Clover Creek Solar Project LLC d/b/a New Frontiers Solar Park
Responses to Siting Board Staff's First Request for Information
Case No. 2024-00253

Request No. 1:

Clover Creek Solar Park
 Owensboro, Catlettsburg
 24" Crude

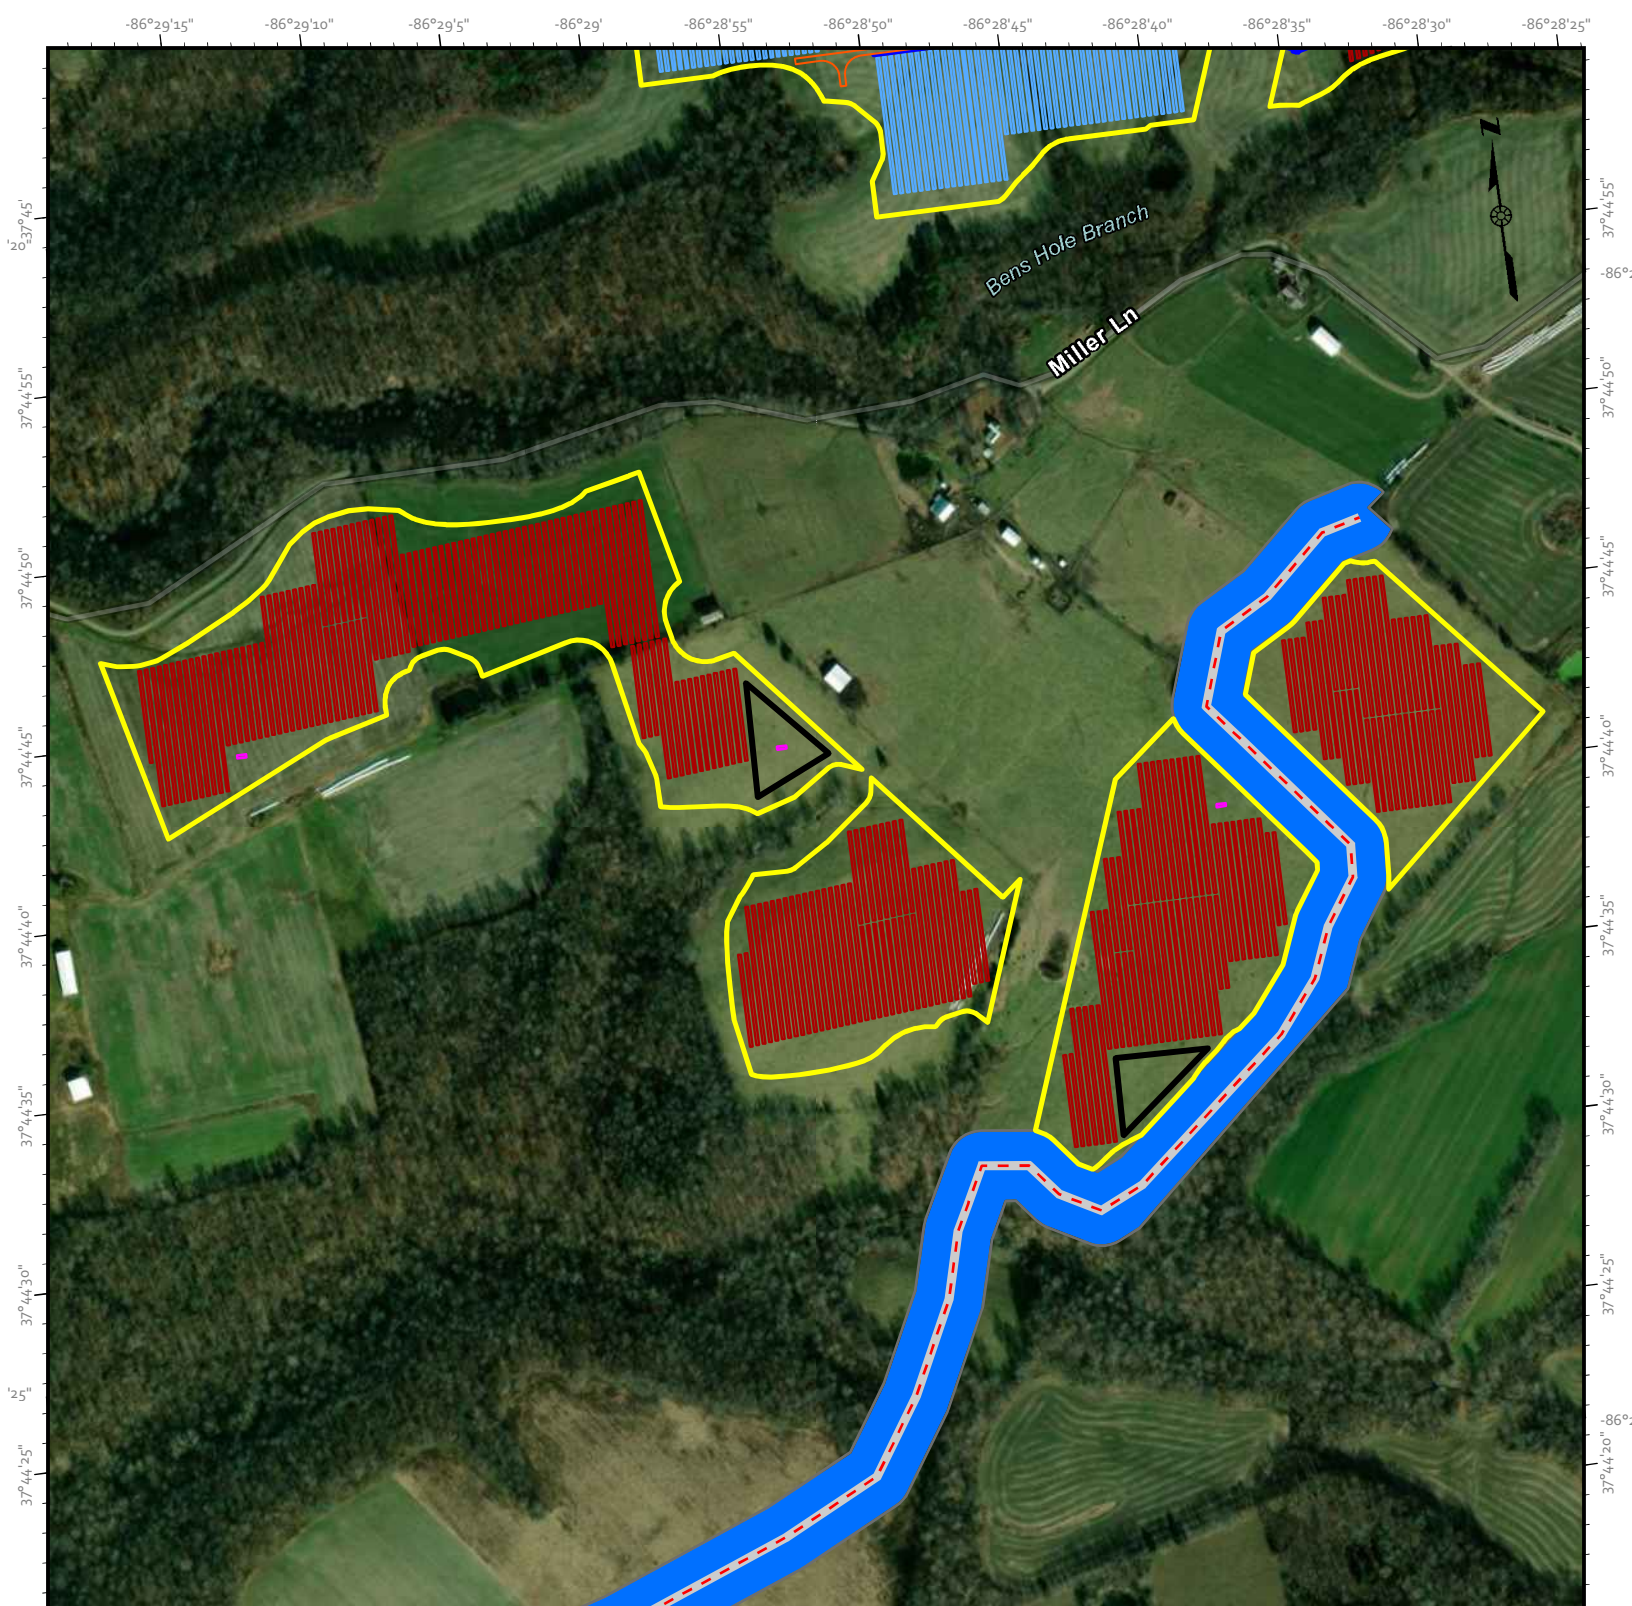
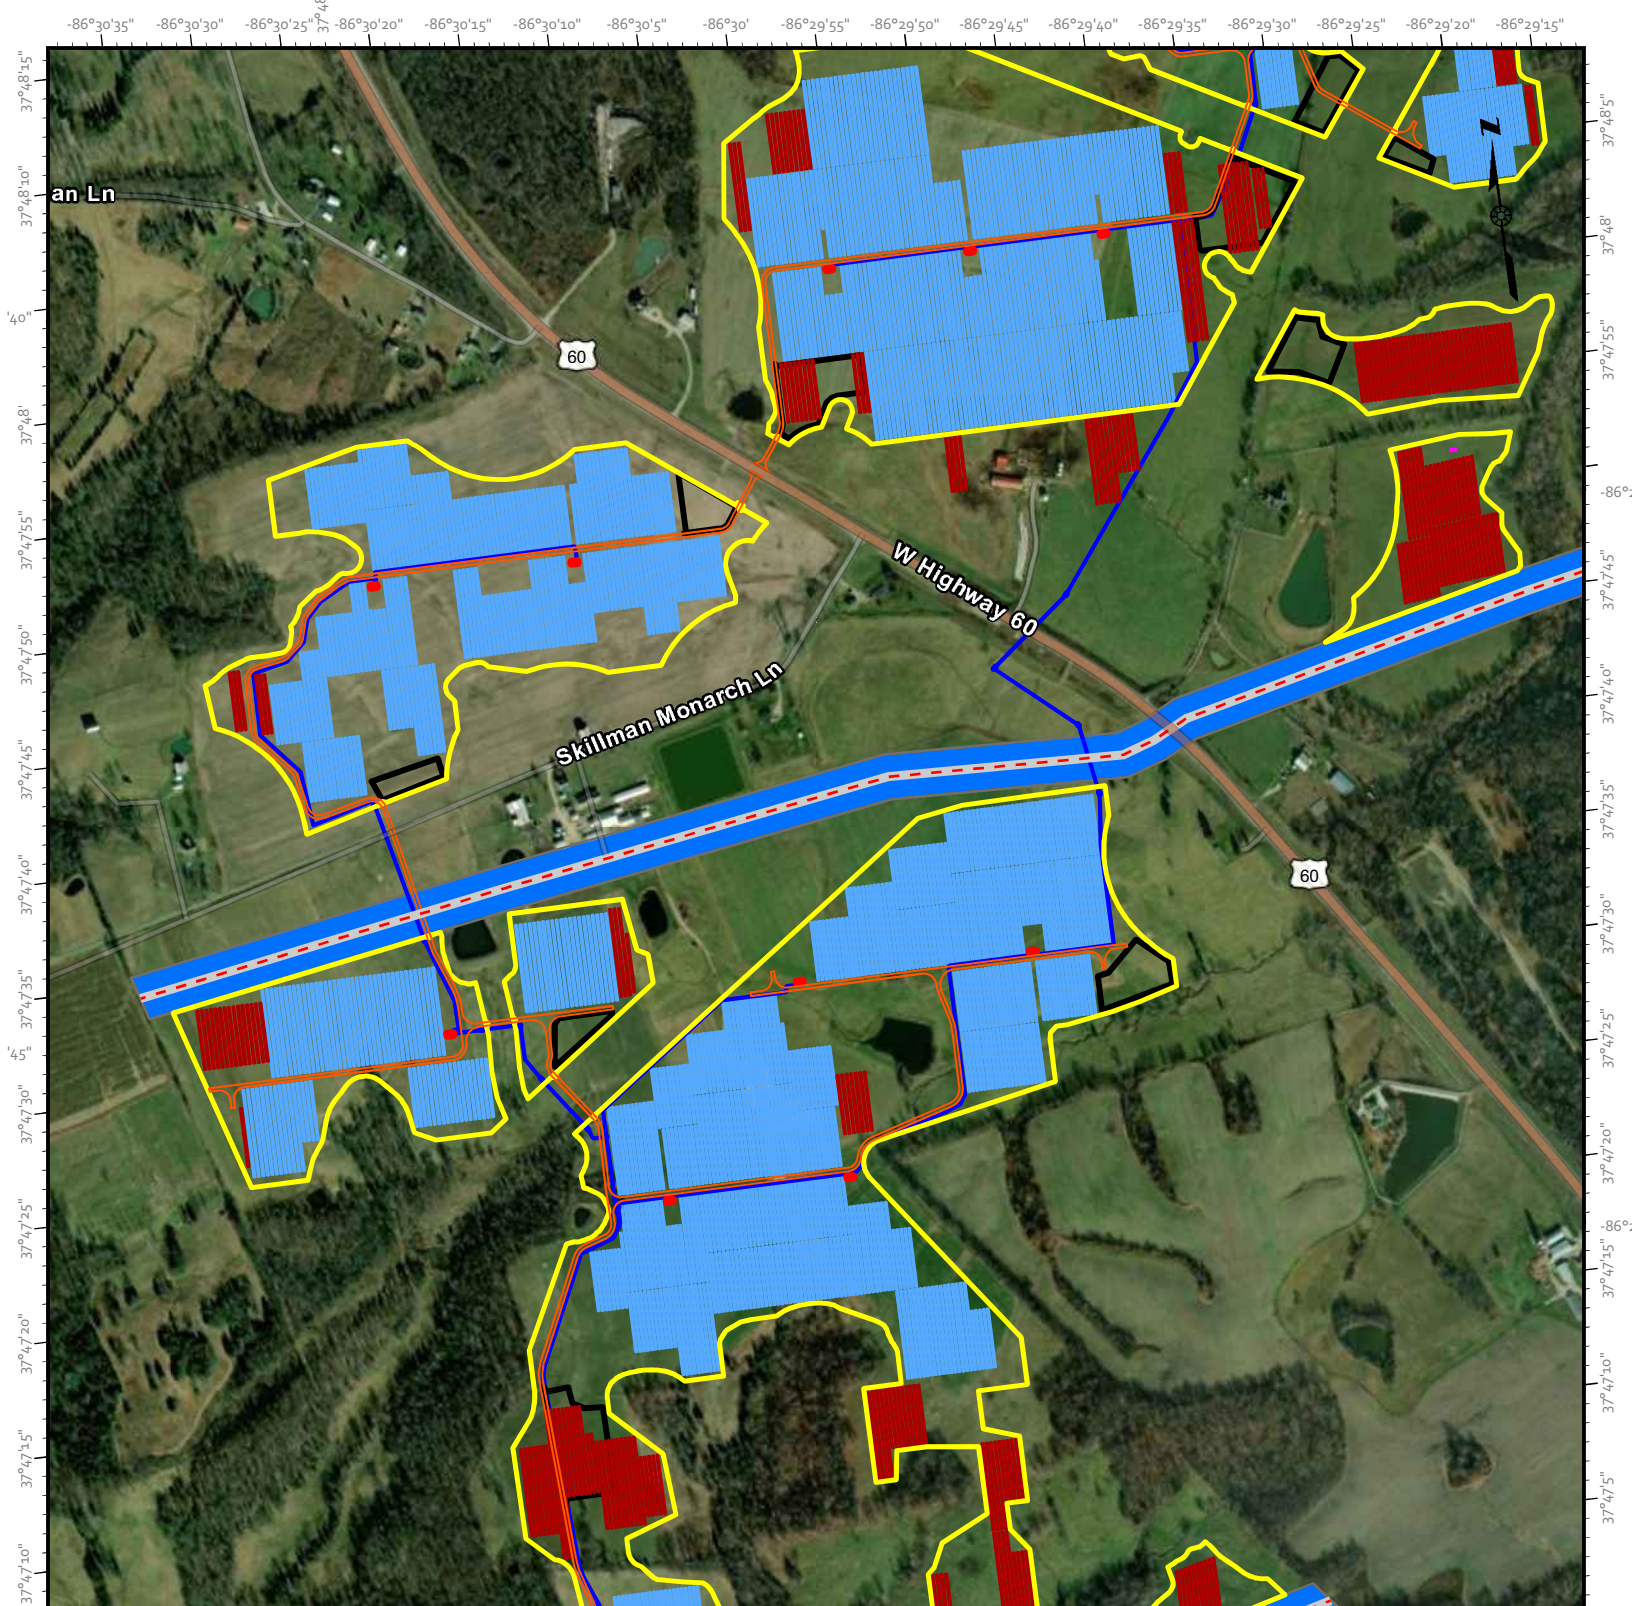
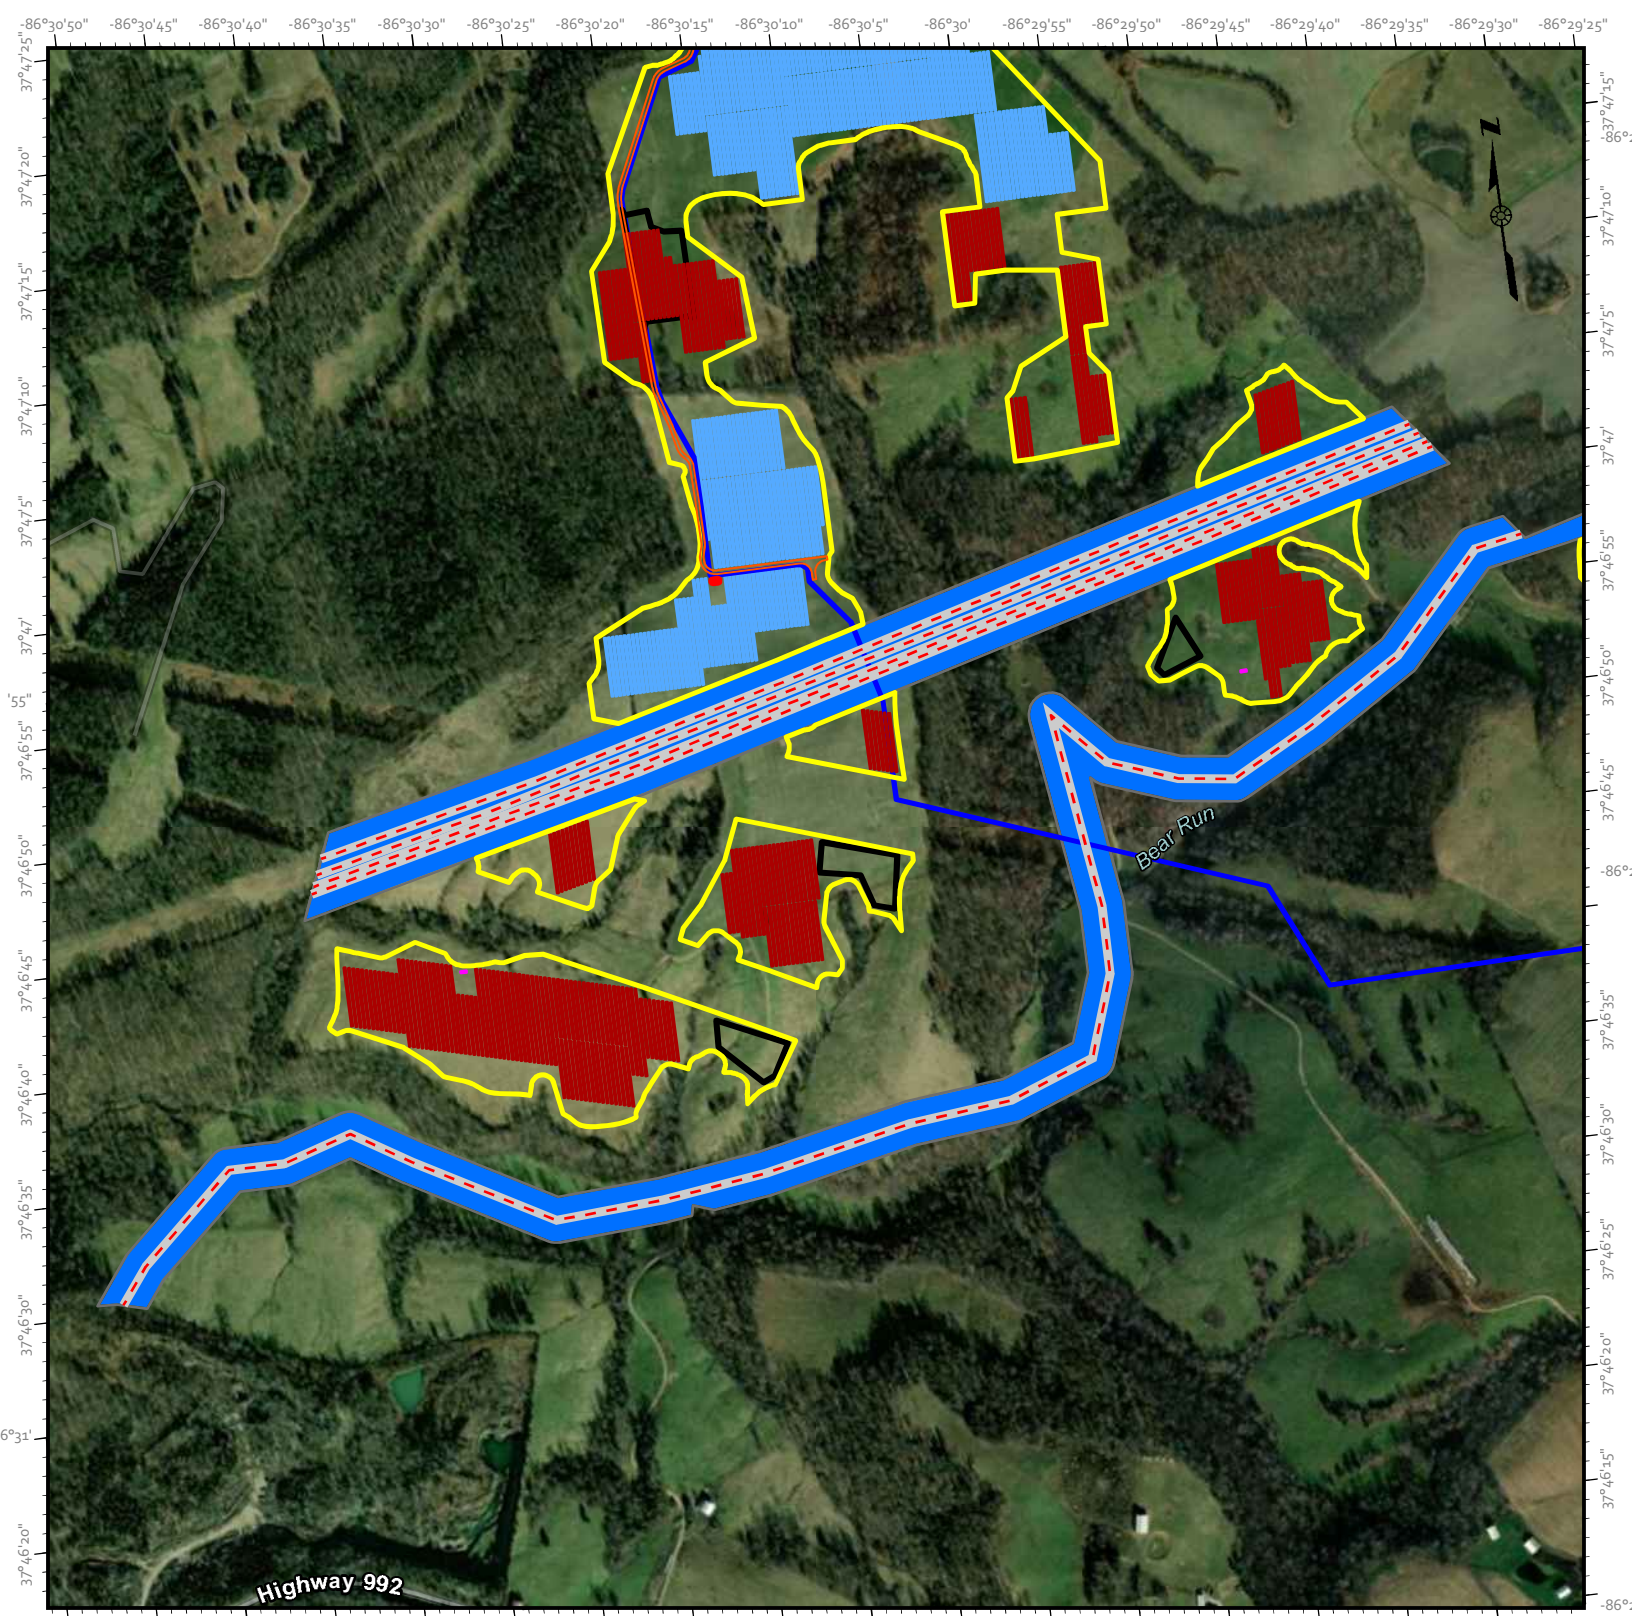
The proposed project site is transected by multiple pipelines, including: A Texas Gas 26" natural gas main pipeline, a Texas Gas 16" natural gas pipeline, and an Owensboro, Catlettsburg Crude 24" crude oil pipeline. Provide:

- a. Any communication with the owners of these pipelines and any concerns that were raised.
- b. The appropriate setbacks from each pipeline.
- c. A map showing the location of all pipelines and their corresponding setbacks from all project components. Include on the map all electric generation components.
- d. Provide how Clover Creek Solar manages to avoid all pipelines, especially with components such as the AC Collection system.

- a. Project representatives communicated with pipeline owners regarding proposed encroachment agreements and setbacks for the Project, including representatives of Marathon Pipe Line LLC and Boardwalk (Texas Gas) Pipelines. Communications included details regarding pipeline locations and possible terms for encroachment agreements. Communications with the pipelines are currently being reviewed for confidentiality under federal and state laws and will be produced at a later date.
- b. Each pipeline in the Project area has been set back 100 feet on either side of the pipeline's center line.
- c. Please see the attached map showing pipeline locations and related setbacks.
